ADDENDUM NUMBER I

DATE: February 9, 2026

PROJECT: Newark Valley Central School District 2023
Capital Project – Phase III
High School Air Conditioning

PARTIAL SECOND FLOOR PLAN - DEMOLITION

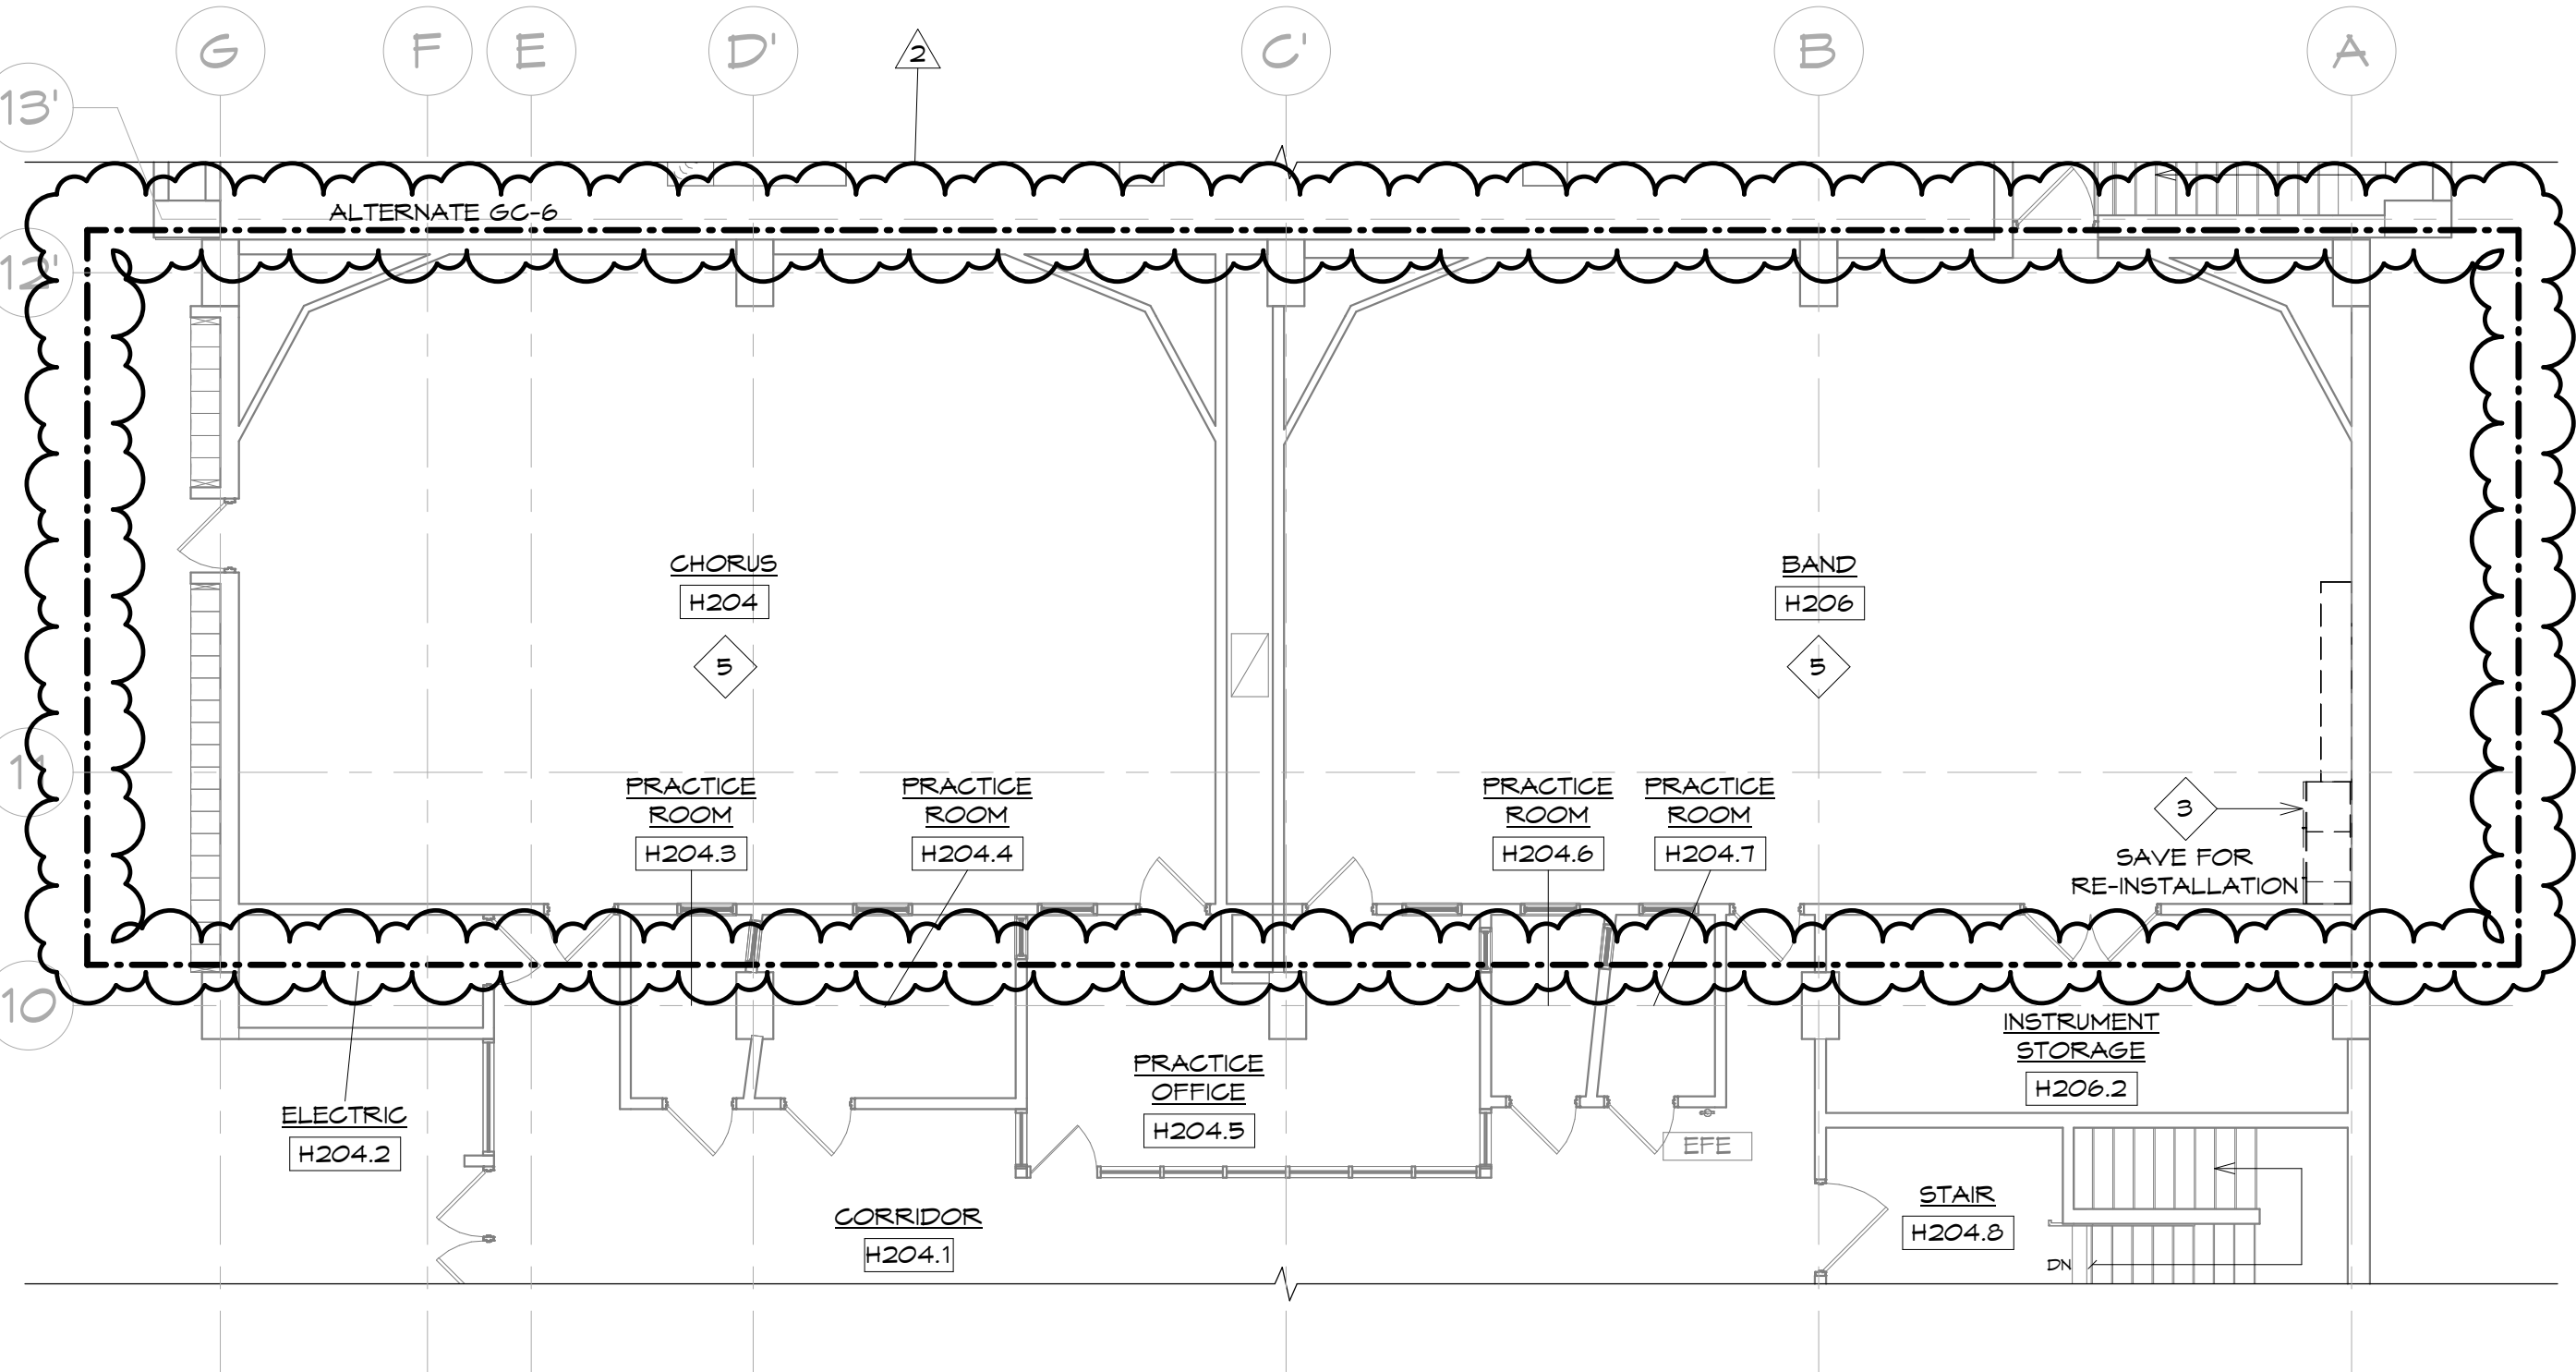
3. A103 – SECOND FLOOR DEMOLITION PLAN

- a. Refer to I/A103; ADD Alternate GC-6 note as shown in the attached drawing A103-ADI.

PARTIAL SECOND FLOOR PLAN - PROPOSED

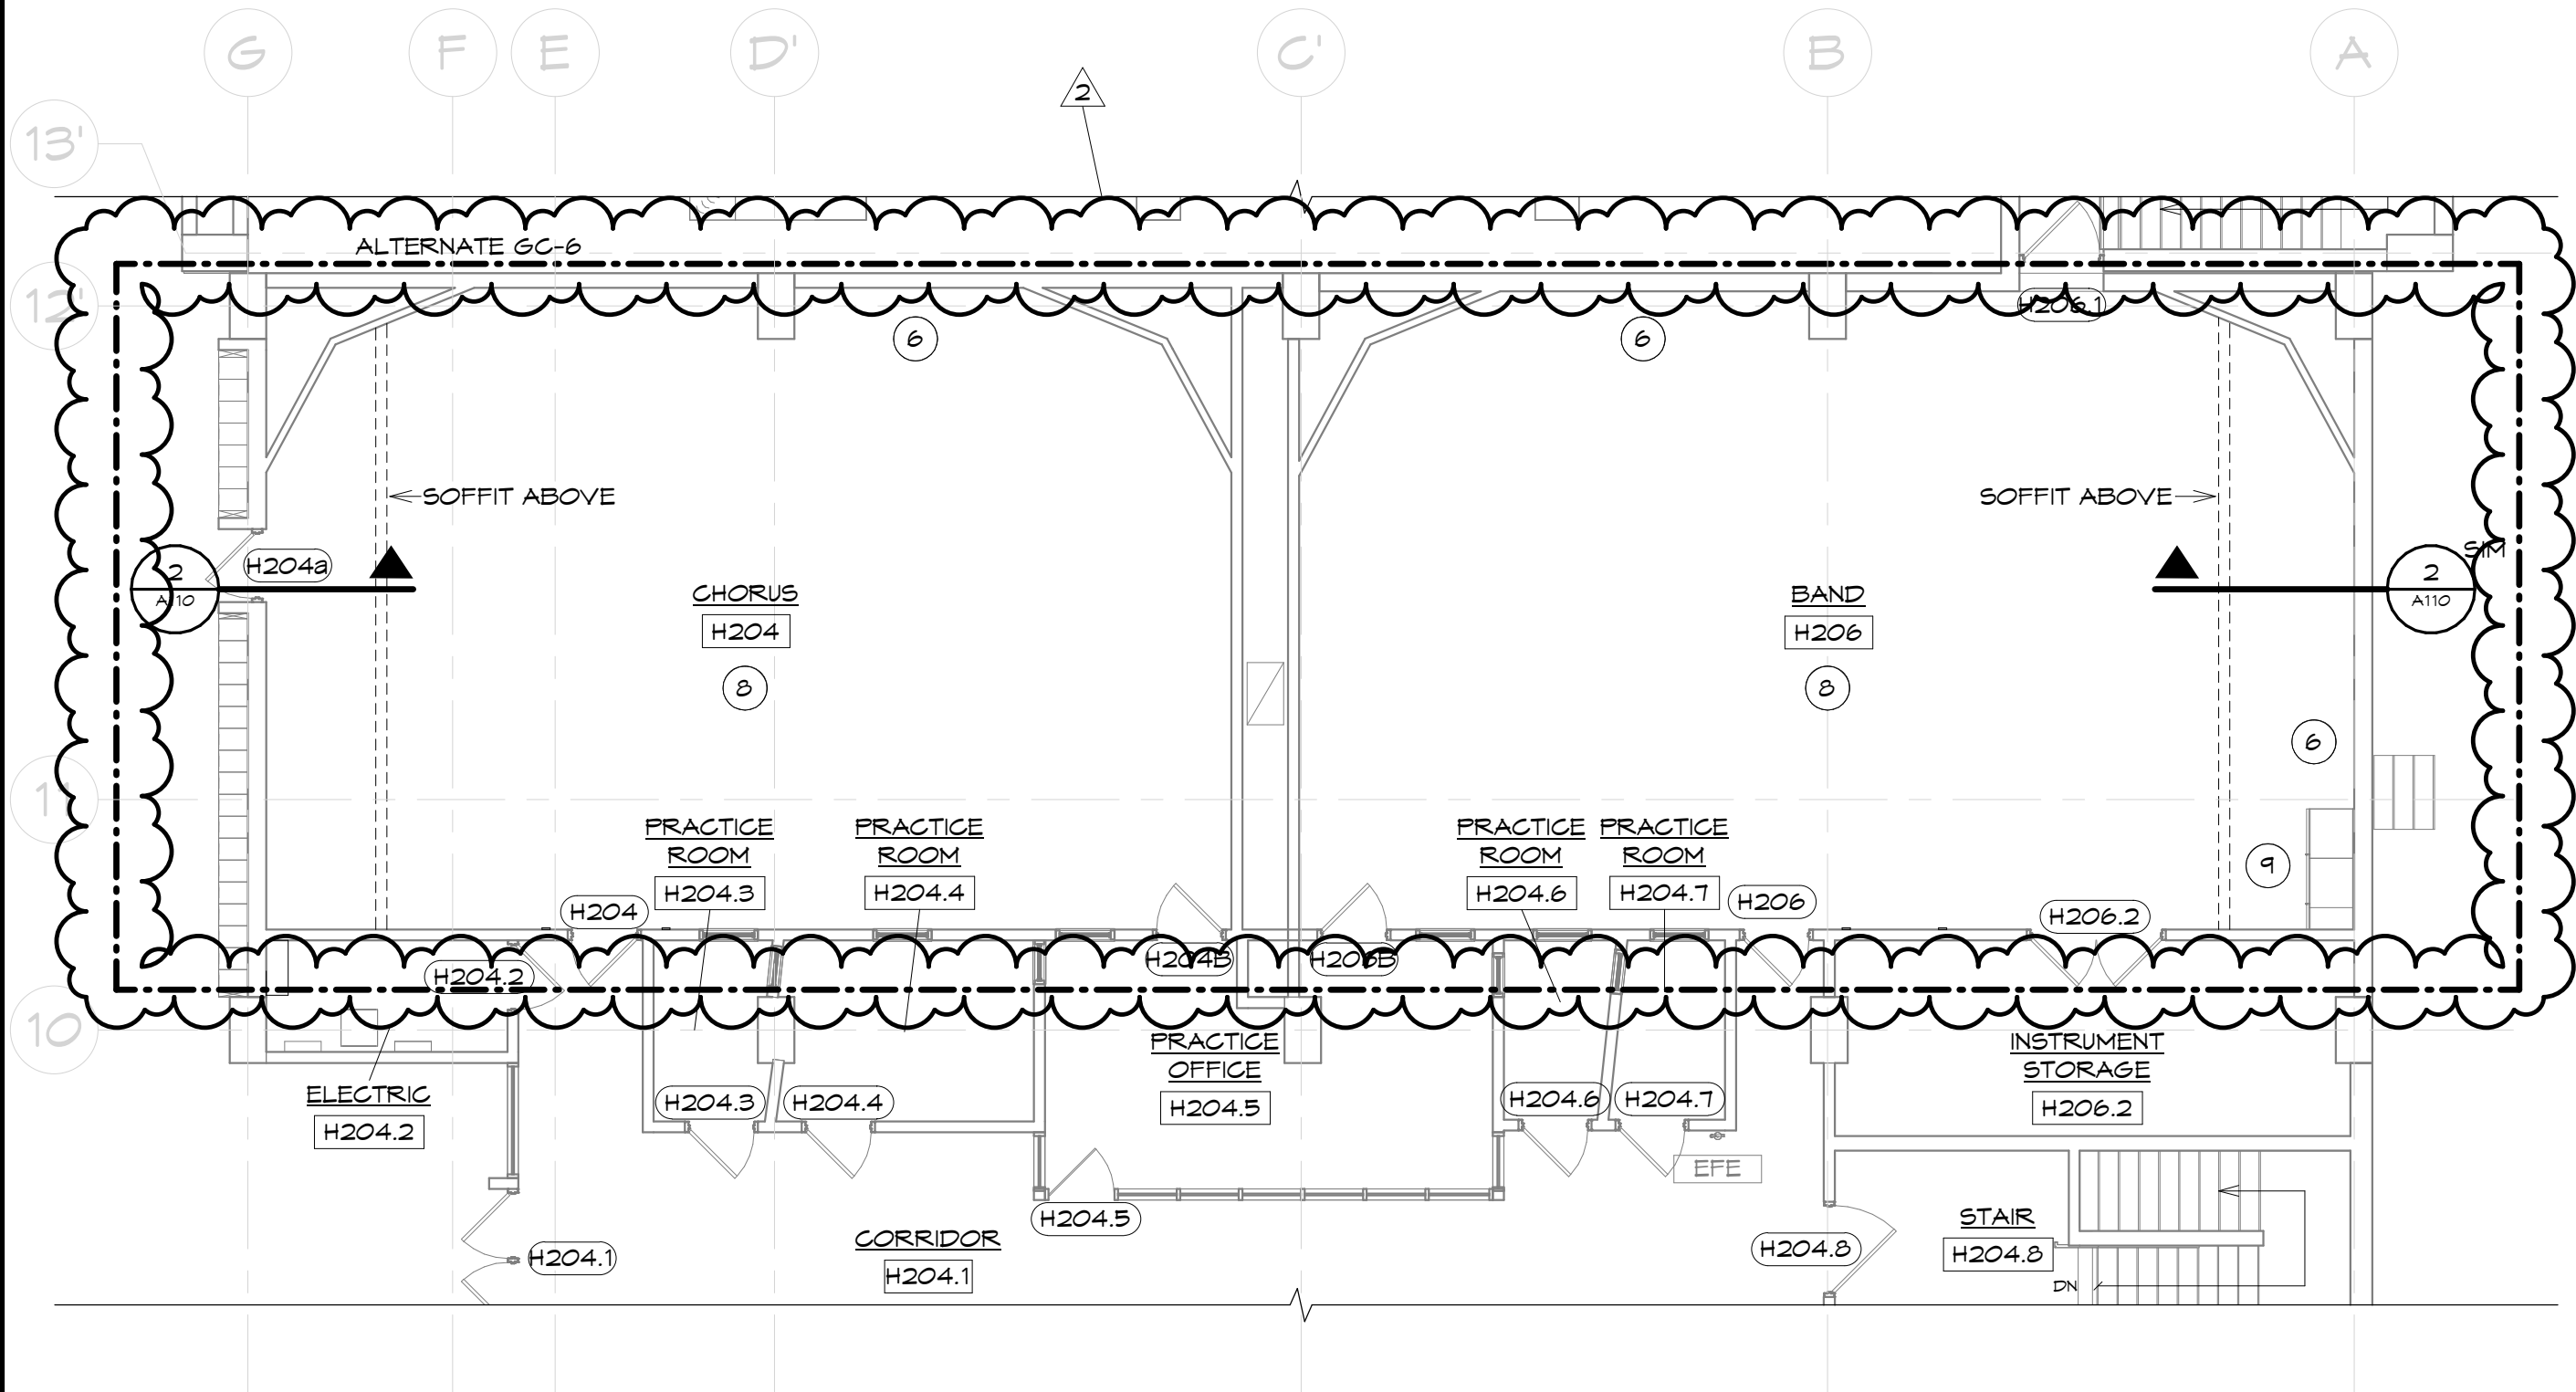
5. A109 – SECOND FLOOR PROPOSED PLAN

- a. Refer to I/A109; ADD Alternate GC-6 note as shown in the attached drawing A109-ADI.

1 FIRST FLOOR MECHANICAL REMOVAL PLAN - AREA 1
M202-AD1 1/8" = 1'-0"

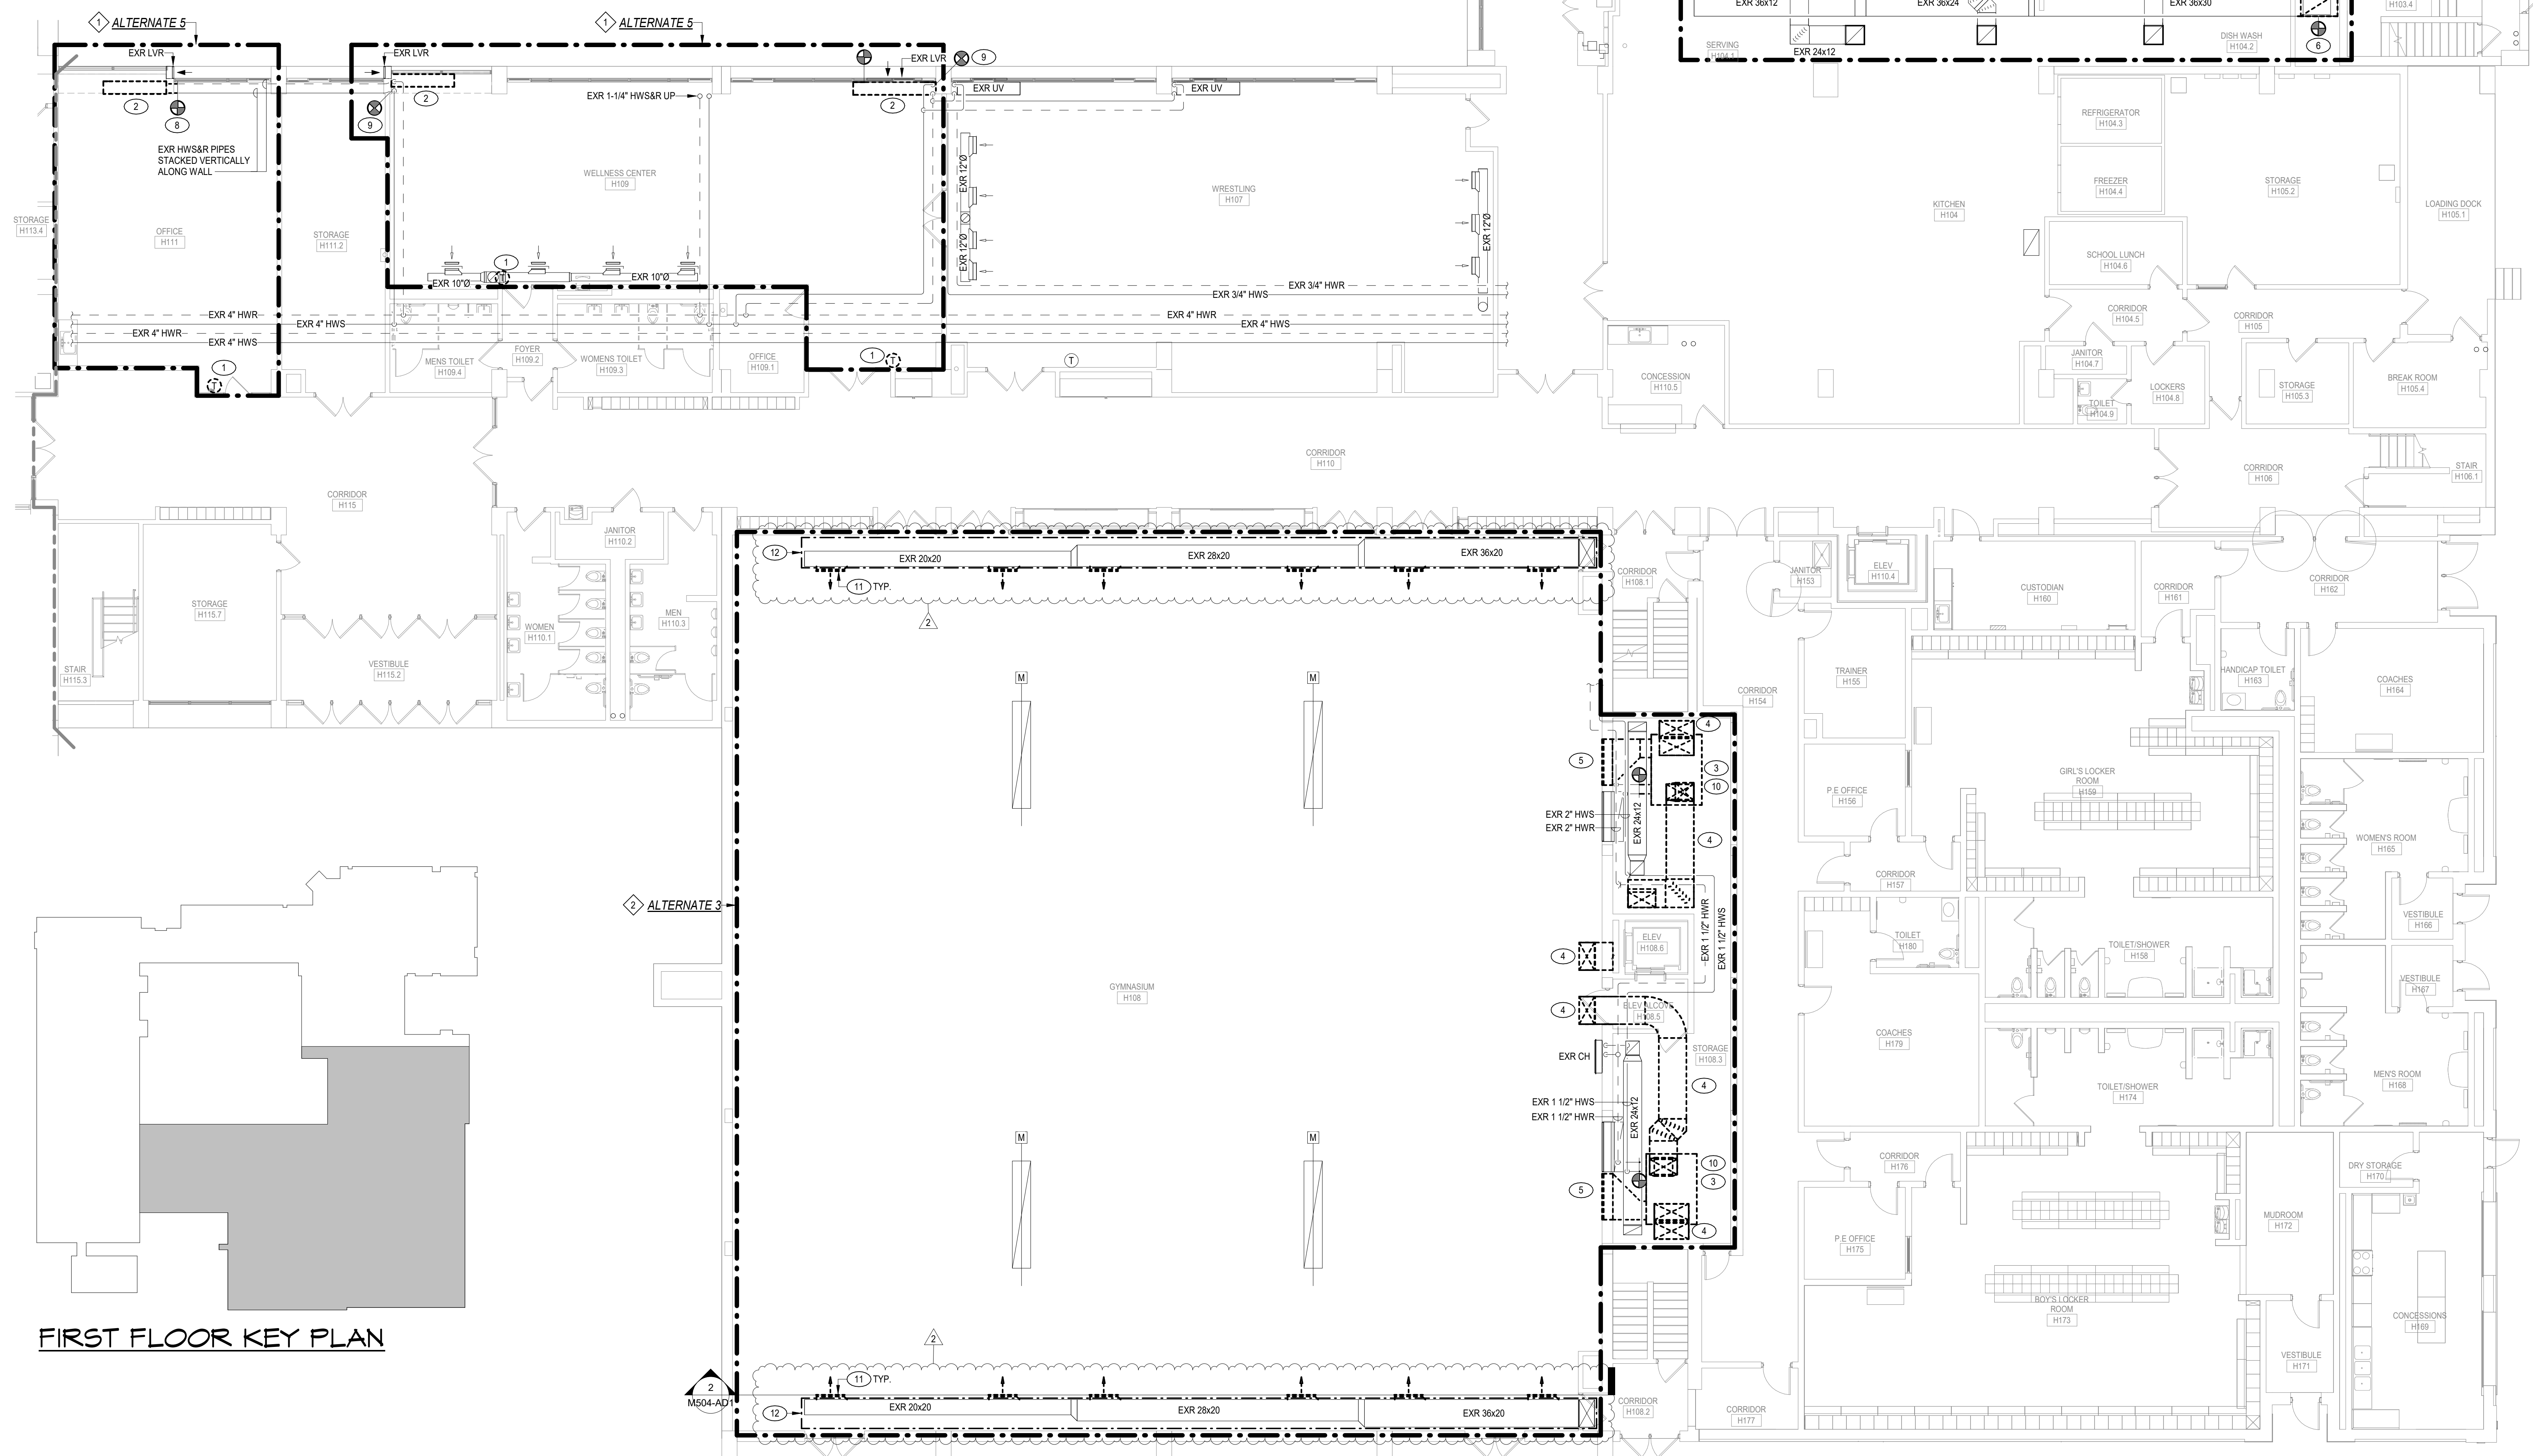
10. M202 - FIRST FLOOR MECHANICAL REMOVAL PLAN - AREA 1

- a. REVISE as shown on the attached drawing M202-ADI.
